Grazing Yak Solar

El Paso County, Colorado

Re-Seeding Plan

SHEET: PL.01

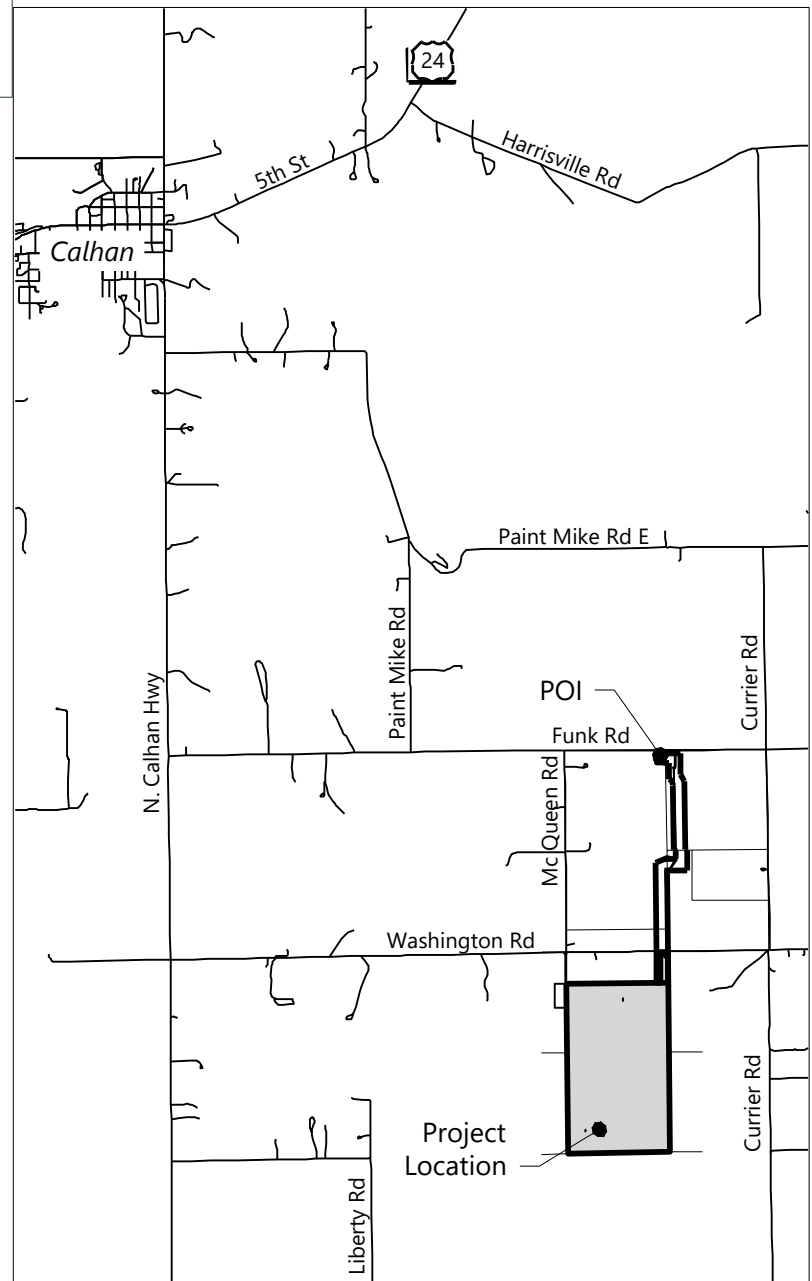
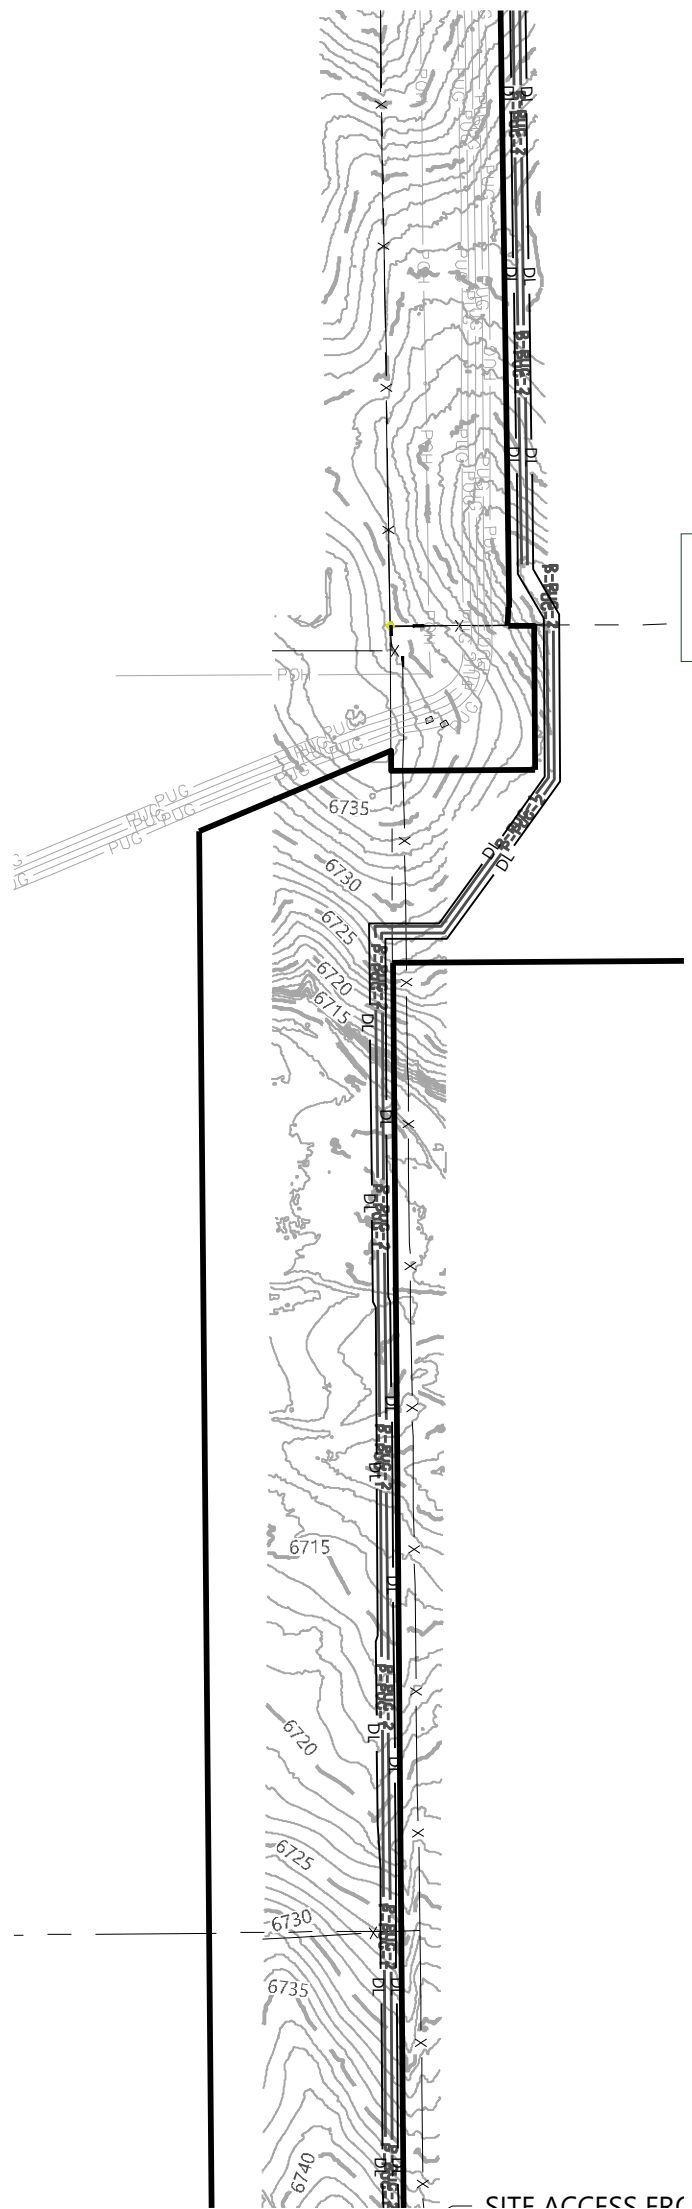
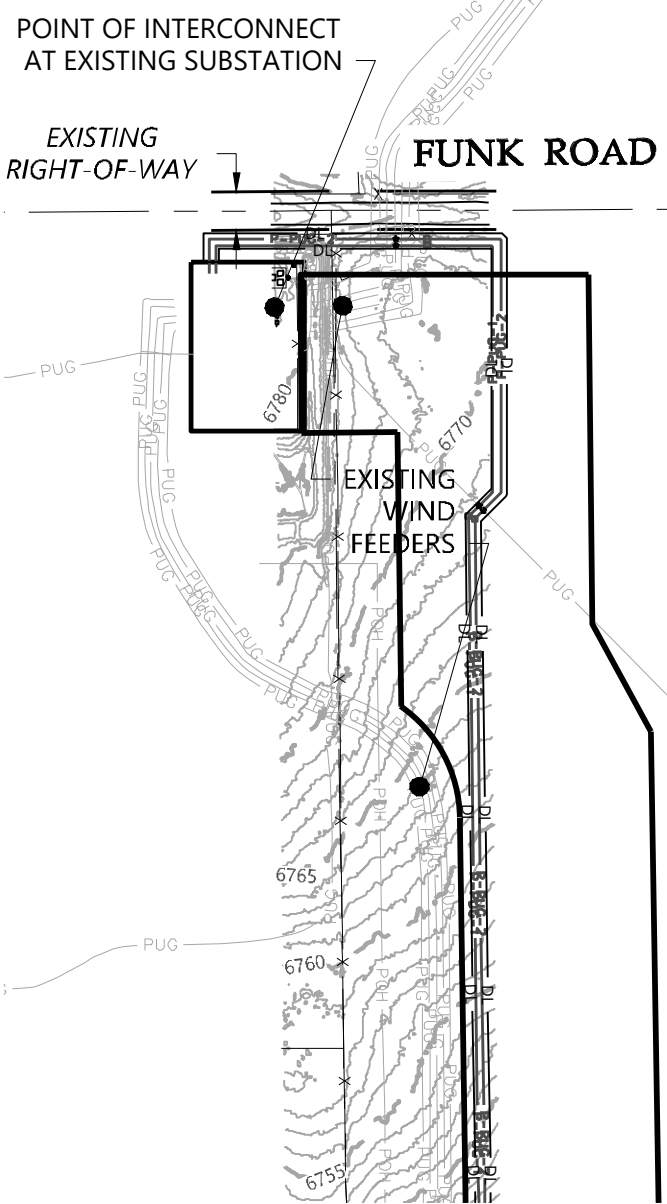
Specify mix(s) and methods include, blanket, watering plan etc... The details must be provided.

Include in the FAE

Identify these setback, fence re-seeding, boundary lines with a leader; it is not clear what lines are which.

This plan is not legible due to the scale

Identify reclamation plan for this area on sheet
